**Johns Manville Corporation**

Subject: Comments to Docket No. FAA-2000-7909

We have carefully reviewed Department of Transportation Federal Aviation Administration 14 CFR Parts 25, 91, 121, 125, and 135 [Docket No. FAA-2000-7909; Notice No. 00-09] RIN 2120-AG91, "Improved Flammability Standards for Thermal/Acoustic Insulation Materials Used in Transport Category Airplanes" (issued September 20, 2000) and have several comments. These comments deal primarily with the burnthrough portion of the NPRM. They are summarized below, and explained in more detail in the discussion section of this letter.

JM results  
FAA results

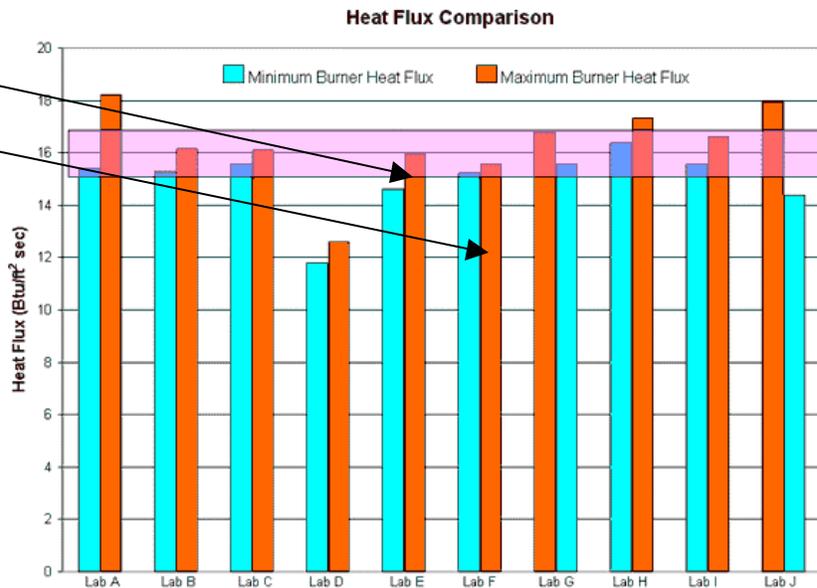
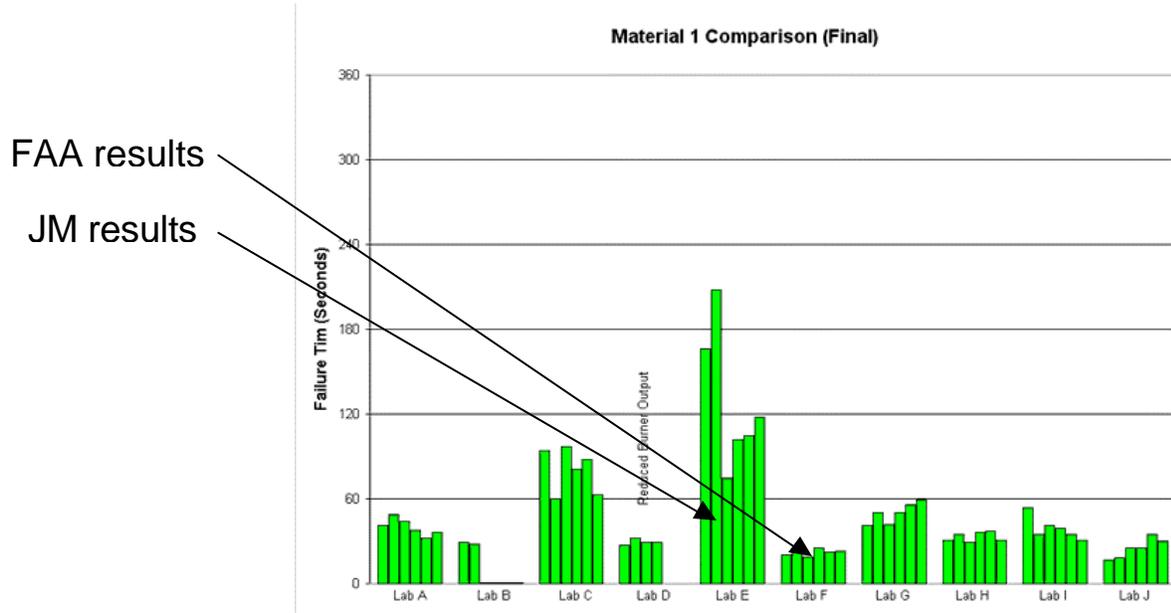
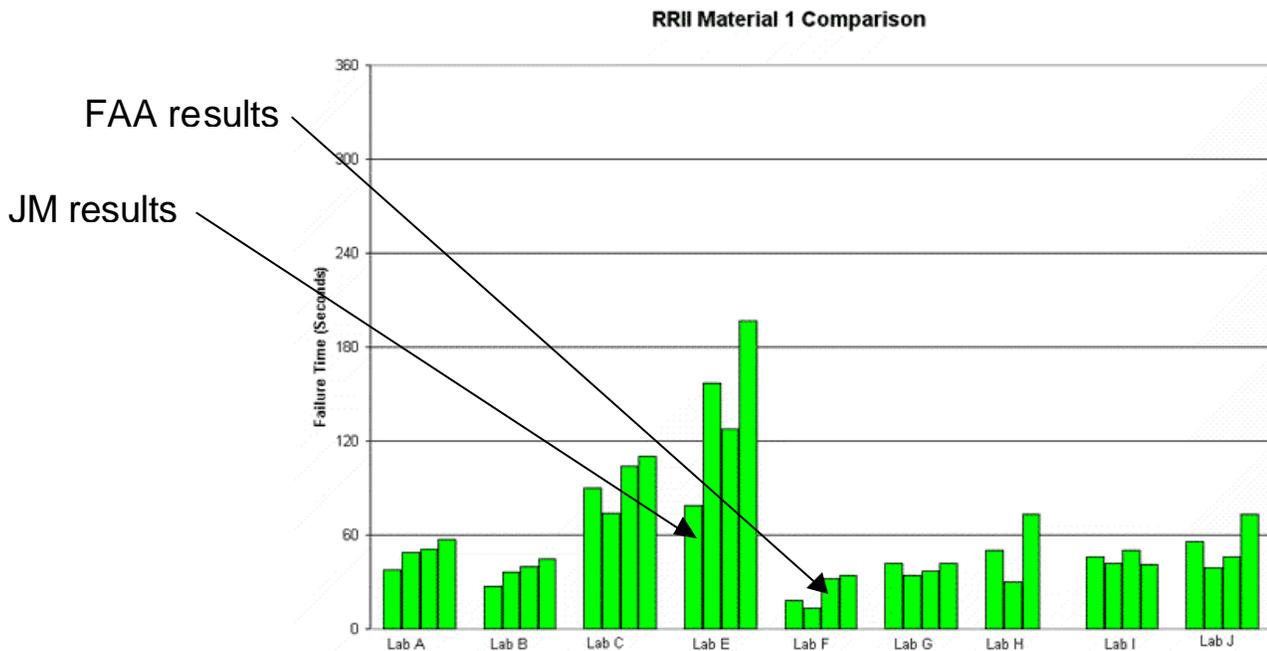
It became apparent during the first Round Robin conducted in early 2000 that despite following the calibration procedure recommended, and despite obtaining temperature profiles and burner heat flux values comparable to those at the FAA Technical Center, our burnthrough test results were vastly different. The graphs below and on the next page show the calibration and test values as they were posted on the FAA website; Johns Manville is Lab E and the FAA is Lab F.

Obviously though the equipment, set-up and calibration was similar, there is a large variation in the test results. Despite efforts to correct this variation with the help and advice of FAA Tech Center personnel, burnthrough results from the Johns Manville Technical Center continued in this manner during Round Robin II:

Based on the data generated, there appears to be some other parameter that affects the burnthrough test result that has not been identified. The obvious difference between our fire laboratory and the others involved in this program is the altitude of the respective fire laboratories. The fuel and air flow levels prescribed for use in this test method are, by FAA design, out of stoichiometric balance. The 6 gallons per hour fuel flow with 2150 fpm air flow is operating at 39% air deficiency for perfect combustion at standard sea level conditioned air. Due to the lower oxygen content in the air at 5,280 feet above sea level, this deficiency of combustion air becomes 49%, which results in a reduction of available heat from Jet A fuel of over 15%.

One would anticipate seeing this difference translate into lower temperatures and heat flux values during calibration. This was not the case during earlier testing as shown in the graphs above, where calibration yielded comparable heat flux and temperature output higher than specified. Conversely, during the current round of testing, even when operating on the upper end of the airflow tolerance (2200fpm), calibration burner heat flux was approximately 12BTU/ft<sup>2</sup>sec, not the 16 targeted by the FAA. Thermocouple rake averages were about 1830°F, within the specified range of 1900±100°F. In addition to this anomaly, this lower heat flux and temperature combination yielded more severe results on the burnthrough samples than the earlier testing.

We believe that some added evaluation of combustion conditions and the potential effect of altitude on test results needs to be done to assure test method reliability for the burnthrough test method. Failure to define these effects could result in skewed qualification of burnthrough materials based on the location of the testing laboratory.

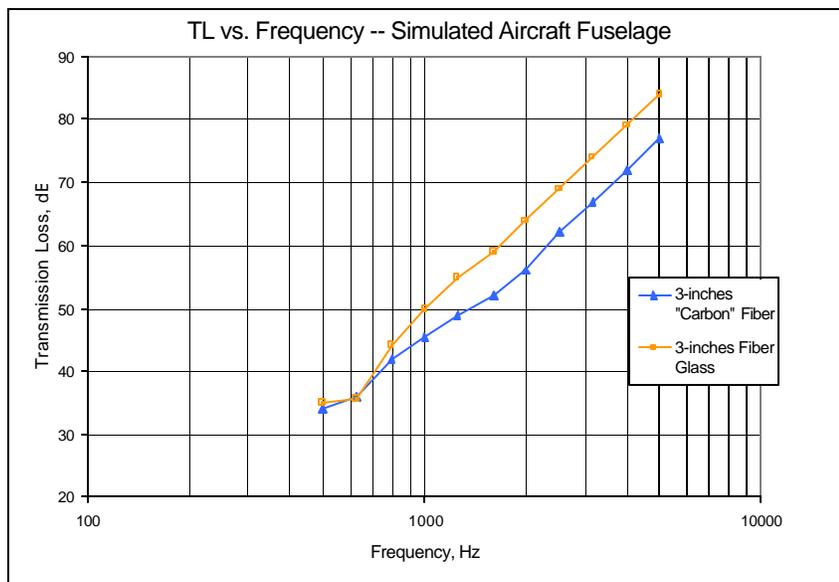
The current insulation bag design and attachment combinations were developed by airframe manufacturers to provide the maximum acoustical protection to the passenger at the lowest possible weight. If one layer of the existing fiber glass batting were replaced with Curlon<sup>®</sup>, blanket designs currently in use would **not** provide acceptable fire-hardening in compliance with the proposed improved flammability standards. A new blanket configuration and fastening method would have to be designed before any passenger safety enhancement is realized. Even though the advisory materials to be issued by the FAA may address the fire hardening portion of the blanket installation and design, these recommendations may prove detrimental to the other properties of the blanket, especially the acoustical transmission loss characteristics. In other words, the design impact could go beyond burnthrough protection if it is advised that the current configurations and attachment methods be changed. There are available burnthrough solutions that do not require blanket configuration and attachment changes, but the one cited in the NPRM, i.e. Curlon<sup>®</sup>, would require significant attachment changes. Without addressing these issues as an integral part of the burnthrough test method, the regulation will not result in practical real-world fire protection without impact on other blanket properties.

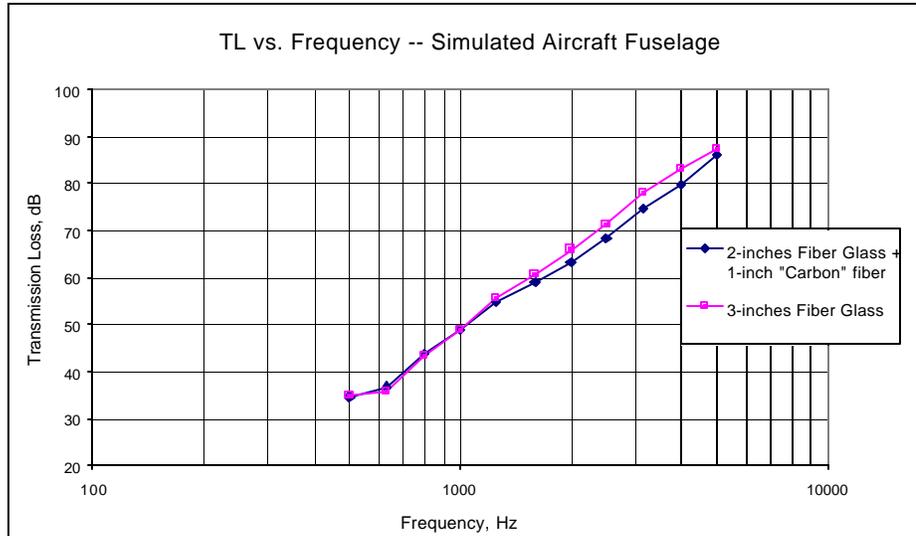
Acoustical test data is graphed below, showing the transmission loss performance of three 1-inch layers of 0.42pcf AA fiber glass in a simulated aircraft fuselage, vs. the performance of three 1-inch layers of "carbon" fiber similar to the lofted Curlon product at 0.35pcf . **Note that higher transmission loss values result in lower interior cabin noise.** Transmission loss differences of 1dB are considered significant in the design of an airplane's acoustical package.

The graph below shows transmission loss data when just one layer of Premium AA fiber glass is replaced with a layer of the larger diameter "carbon" fibers. Again, 1 dB is significant; at some frequencies critical to speech interference, 2000Hz for example, the difference is more than 2.5dB.

Although the Curlon material tested acoustically is not the exact same material being produced currently, the fiber diameters and airflow resistance of the current product are comparable. Acoustically they would be expected to perform in a similar manner. In order for the system utilizing this product to provide an equivalent level of acoustical protection to current blanket designs, further insulation and weight would have to be added.
